UCM Series IP PBX Firmware Release Notes

FIRMWARE VERSION 1.0.33.7

UCM6301, UCM6302, UCM6304, UCM6308, UCM6300A, UCM6302A, UCM6304A, UCM6308A

Figure 1 - Integration of Collaboration Platforms

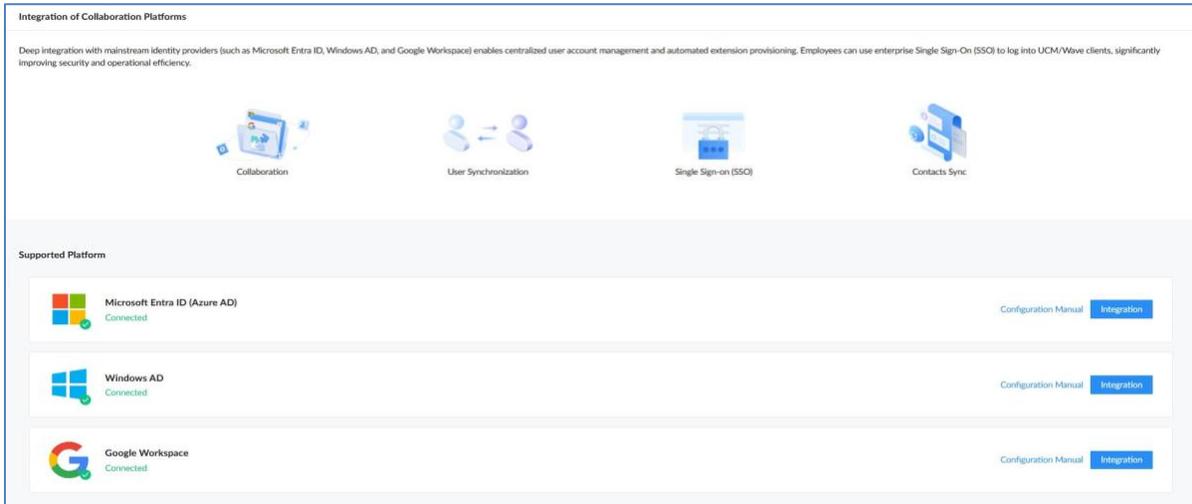
Microsoft Entra ID (Formerly Azure AD), Windows AD, and Google Workspace are now all under the new **Integration of Collaboration Platforms** page under the **Integrations** section, providing a centralized location for 3rd party user platform integration configuration.
